National Highways Planning Response (NHPR 24-02) Formal Recommendation to an Application for Planning Permission

Council's Reference: NH/23/04120

Location: Land East of Ansty Way, Cuckfield

Proposal: Outline planning application (All matters reserved except for access) for the redevelopment of land to the east of Ansty to create a new Garden Community, comprising of the erection of up to 1,450 homes (including 30% affordable housing), up to 90 residential care units (C2 class), a primary school, a SEND school, health hub, sports facilities including all weather hockey pitches and tennis centre, allotments, retail, community and employment uses together with ancillary and associated development including new and enhanced pedestrian/cycle routes, open spaces, and landscaping

Figure 1: Traffic Flow Diagram – Example of Apparent Anomalies

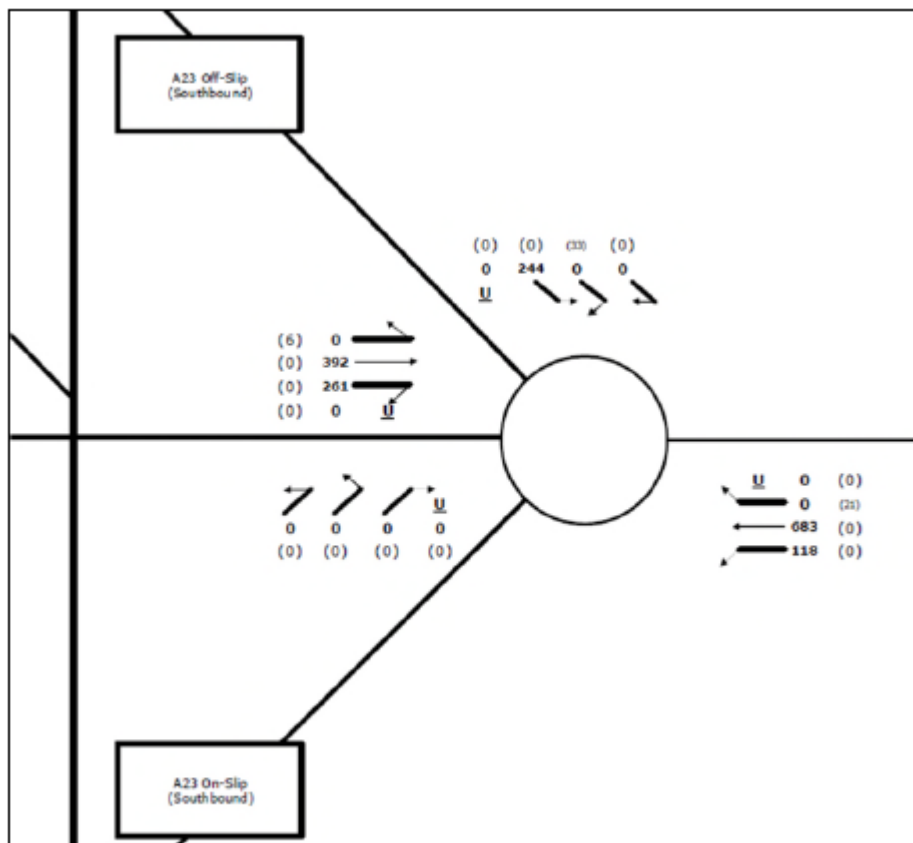
There are instances where the traffic flow diagrams show the 'total traffic flow' as zero, but then there is an amount of heavy goods vehicles reported, the reverse is also apparent with total traffic flows having zero heavy goods vehicles where this is

not likely to be correct. **This should be reviewed within all traffic flow diagrams and corrected where necessary.**

An example is shown in Figure 1, highlighting the A23 / Bolney Road / Cowfold / Crossroads roundabout.

In association with this we request the applicant to explain why the right turn from the A23 southbound off-slip to Cowfold Road has zero traffic flows, as our technical advisors do not accept this as reasonable.
